LEGAL NOTICE EXETER PLANNING BOARD AGENDA

Date: May 15, 2024
To: Planning Board
From: Dave Sharples, Town Planner
Re: Meniscus Financial Holdings LLC – 127 Portsmouth Avenue
PB Case #24-1

RE: Letter of Explanation
Foss Motors
Proposed Vehicle Storage Area & Accessory Storage Use
Tax Map 0052 Lot #: 112.2

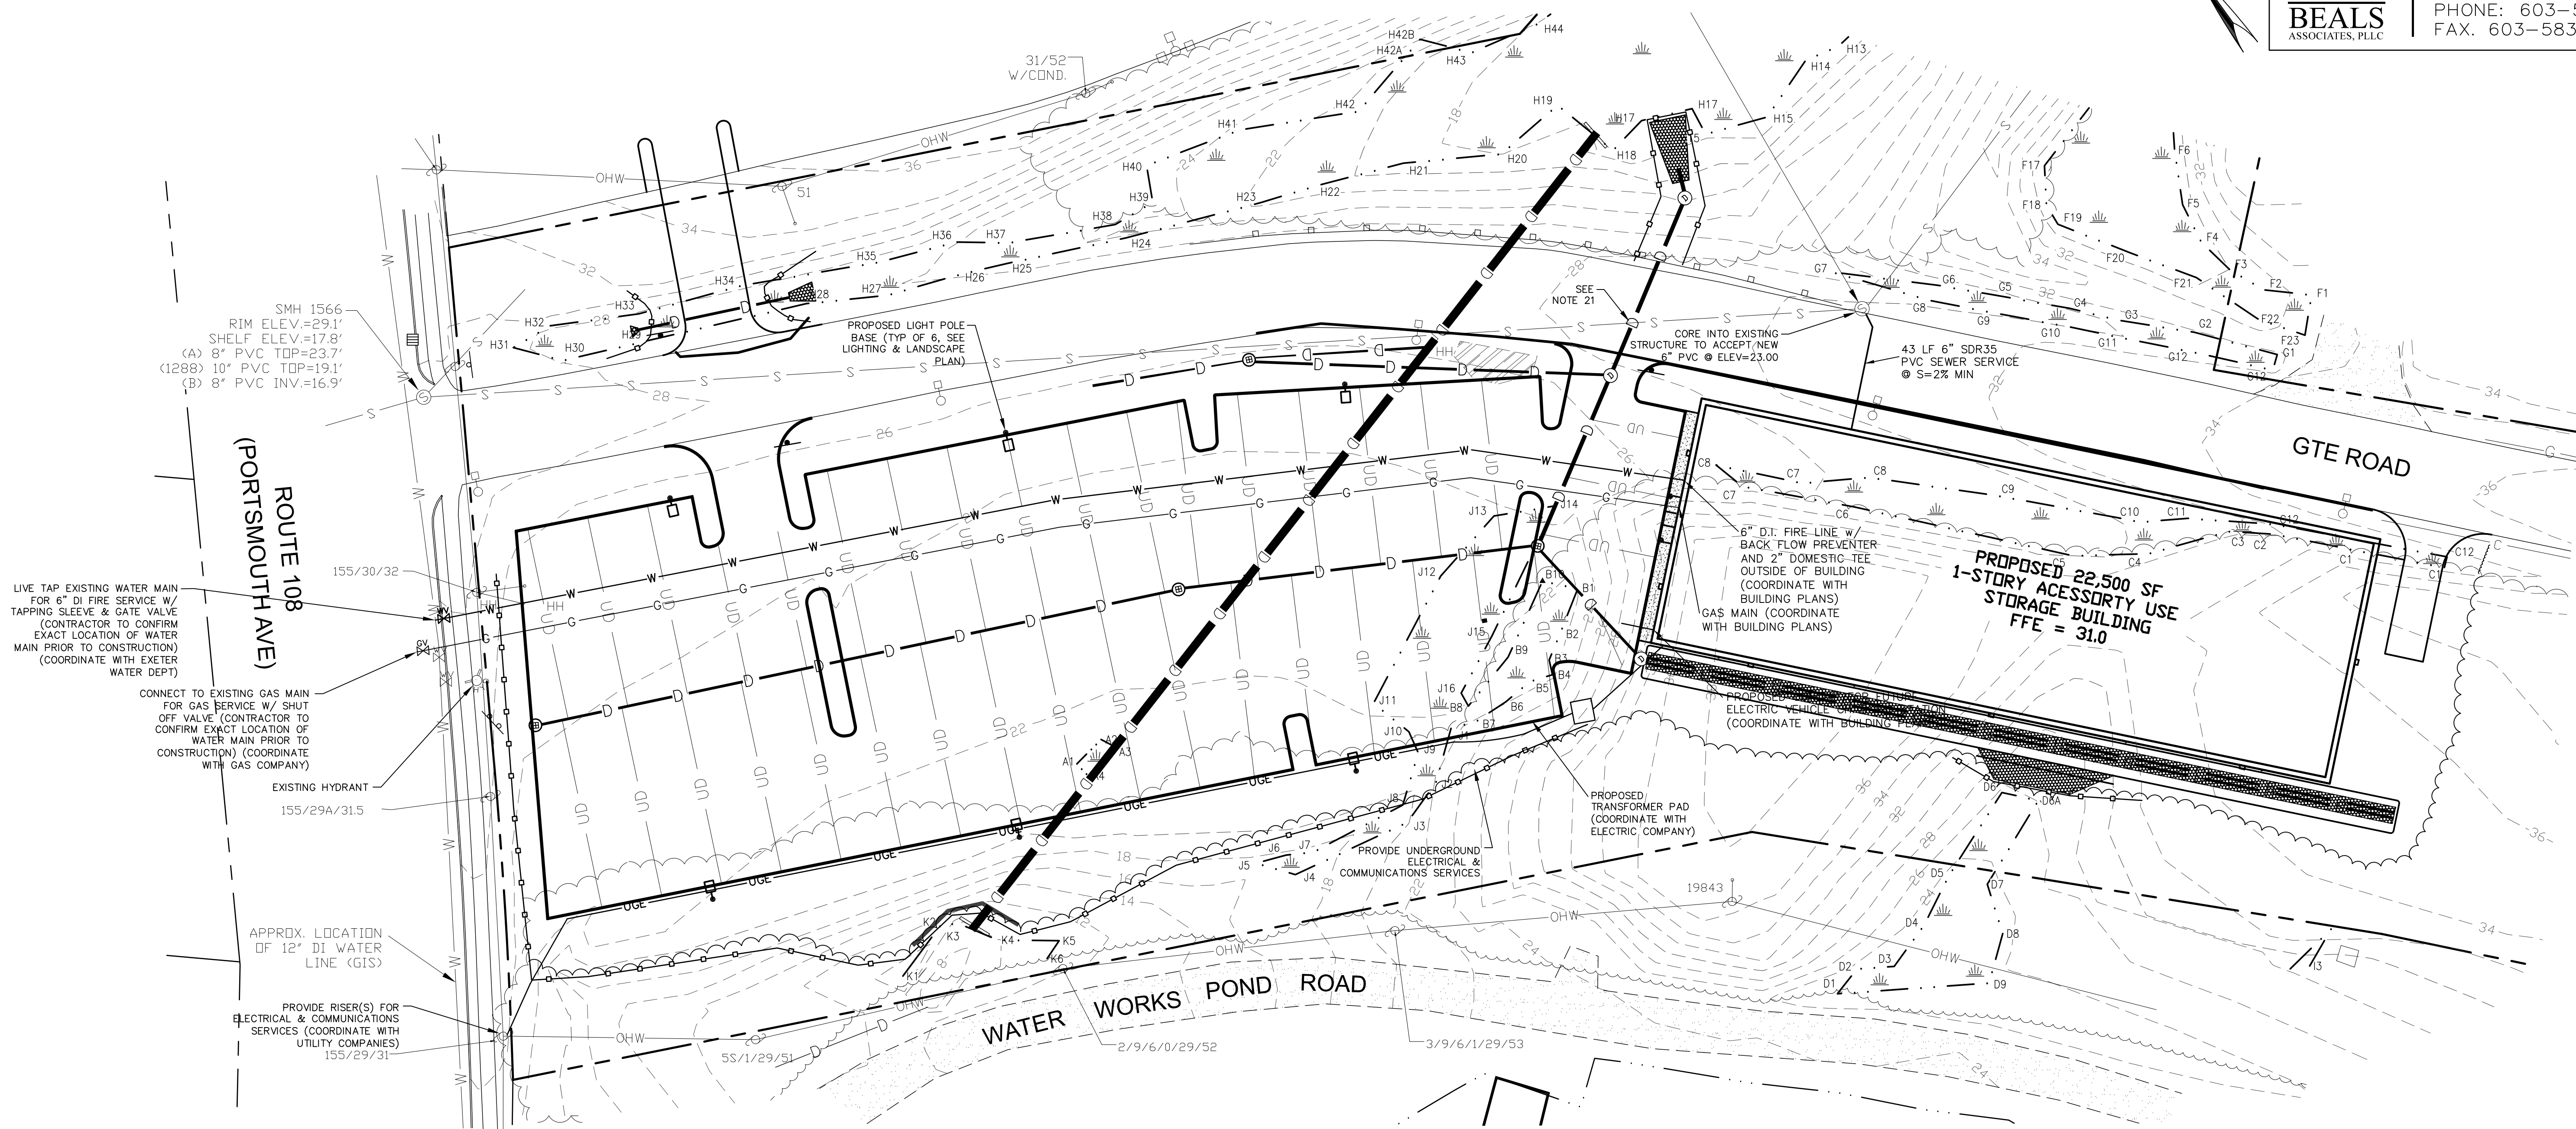
Response: We have added note #14 to the Site Plan (Sheet 3) indicating that a spill response kit be maintained on site.

- a. The BayFilters have been removed from the drainage design in lieu of porous pavement.***
- b. The outlet control structure has been removed from the drainage design.***
- c. Rather than proposing a concrete washout pit within the shoreland district, note #15 has been added to the Site Plan (Sheet 3) to remove excess concrete from the site.***

EXETER LADDER TRUCK MANEUVERING PLAN	
COMMERCIAL DEVELOPMENT ROUTE 108 EXETER, NH TAX MAP 52, LOT 112.2	
PROJ. NO: NH-1471	SCALE: 1" = 30'
SHEET NO. 10

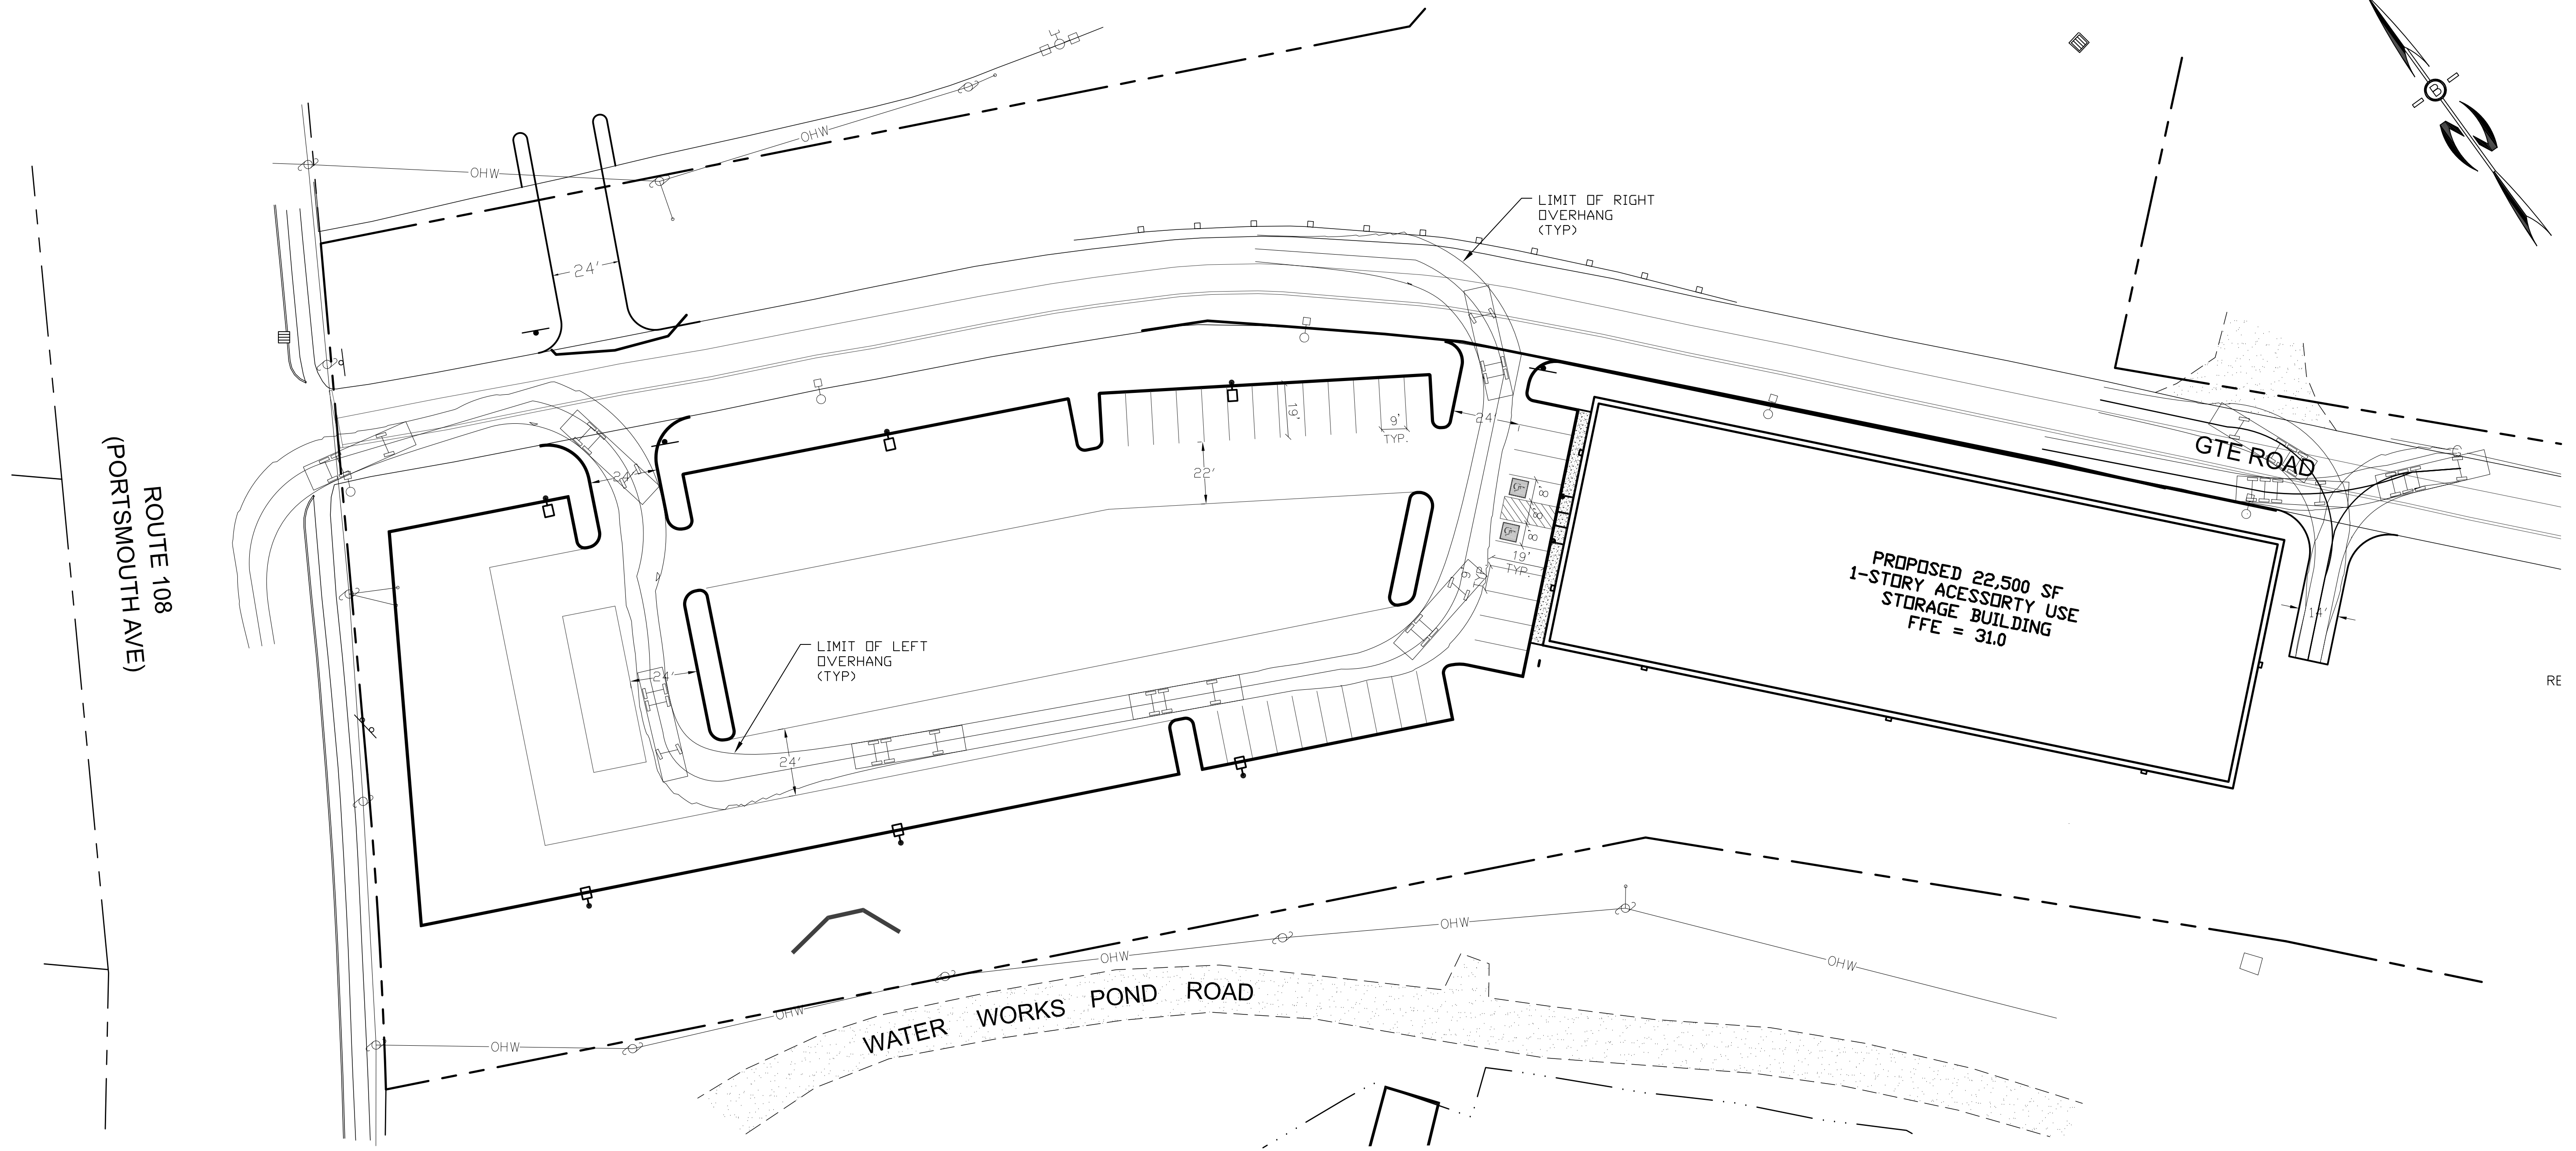
Response: The Exeter Fire Truck is anticipated to be the largest vehicle to access the site and a turning template has been included on Sheet 11.
